LOCATION: Woody Road, southwest of C. F. Hawn Freeway/ U.S. Highway No. 175

REQUEST: An application-to create a 5 lot-Shared Access Development ranging in size from 10,041 square feet to 10,354 square feet from a 1.435-acre tract of land in City Block 8806 on property located on Woody Road, southwest of C. F. Hawn Freeway/ U.S. Highway No. 175.

1:2,400	<h3>AERIAL MAP</h3> <p><input type="checkbox"/> Area of Request <input type="checkbox"/> Recent History</p>	Case no: <u>S234-102</u> Date: <u>4/26/2024</u>
--	---	--

SHARED ACCESS DEVELOPMENT
LOTS 1-5, BLOCK A18806
 BEING PART OF CITY BLOCK 8806
 ROBERT KLEBURG SURVEY,
 ABSTRACT NO. 716
 CITY OF DALLAS, DALLAS COUNTY, TEXAS
 ENGINEERING PLAN NO. 01_____
 DATE: 08/02/2024 / JOB # 2200772 / SCALE: 1" = 20' DRAWN: KO
 PAGE 3 OF 4

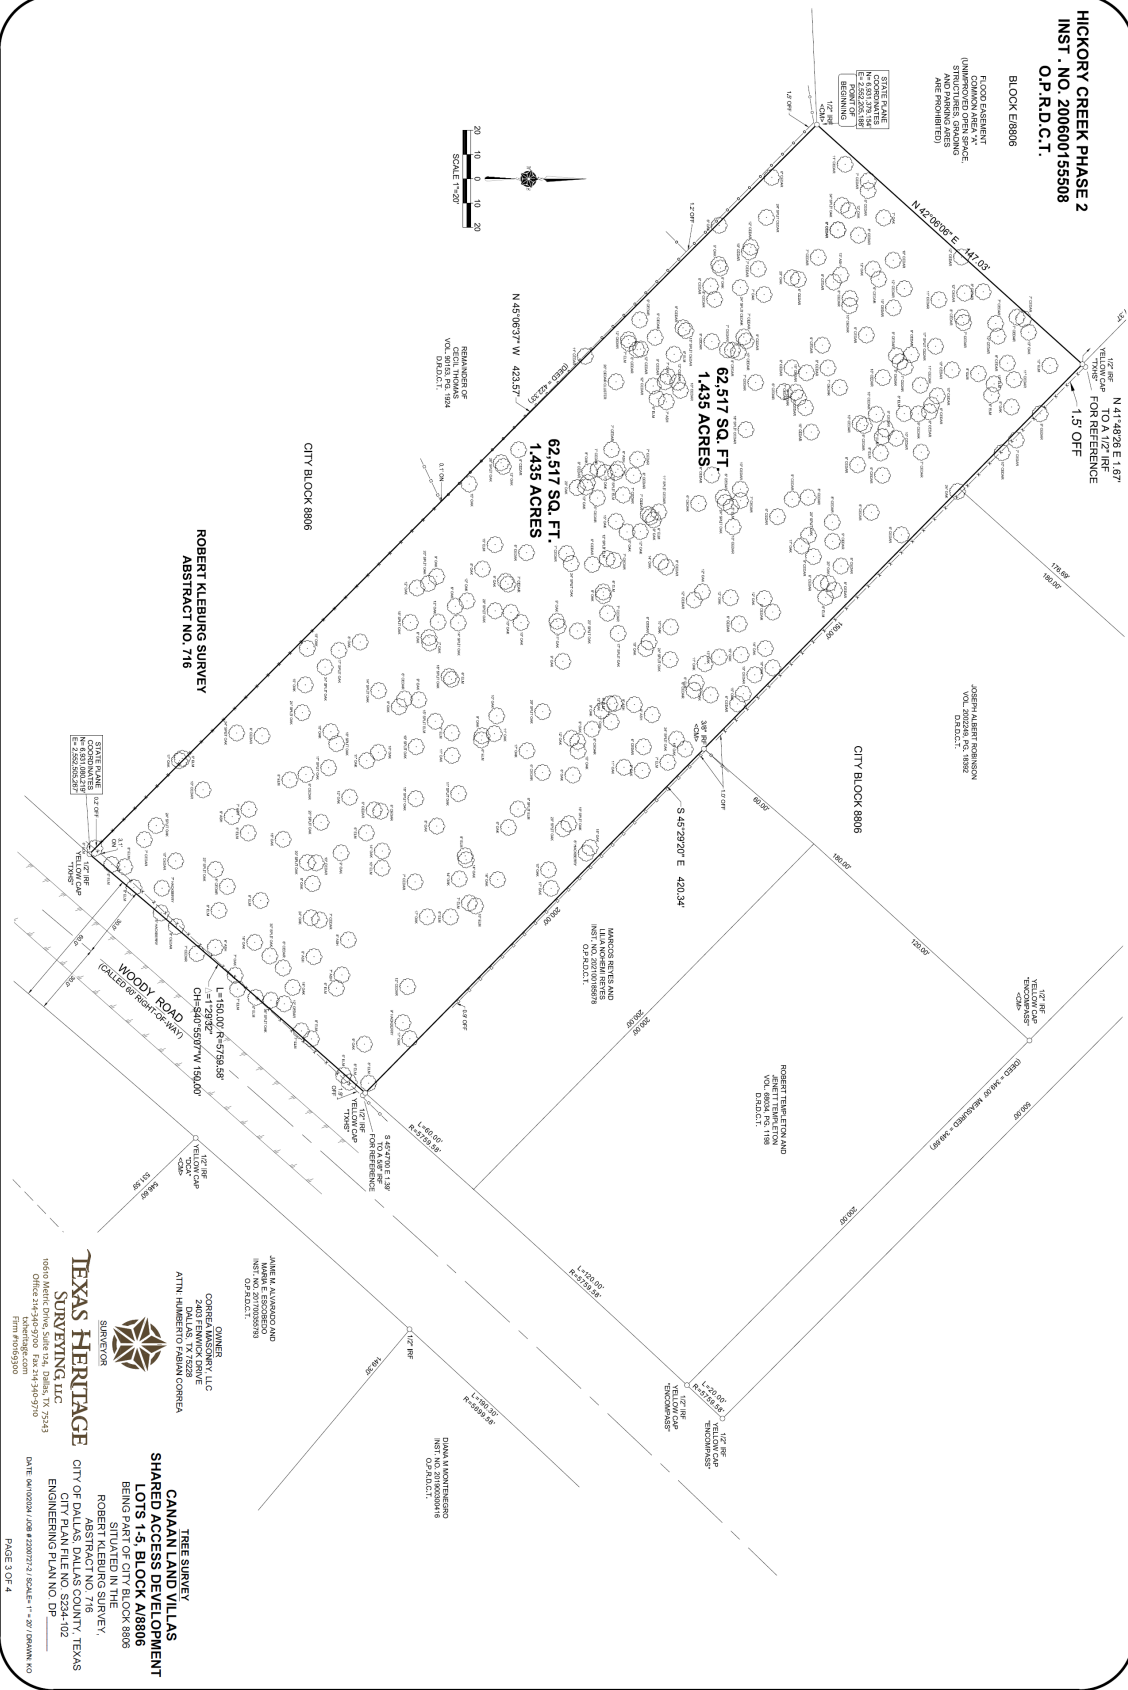
34. Prior to final plat, portion of fencing appears to lie within right-of-way of Woody Road. Please relocate onto owner’s property or remove. Provide documentation to Real Estate to confirm.
35. On the final plat, in the vicinity map, remove the notation Park in the area to the southwest of the site and replace with Kleberg Cemetery-this is neither City - owned land nor a park.
36. On the final plat, change “Woody Road” to “Woody Road (AKA Woody Lane)”.
37. On the final plat, identify the property as Lots 1 through 5 in City Block P/8806.
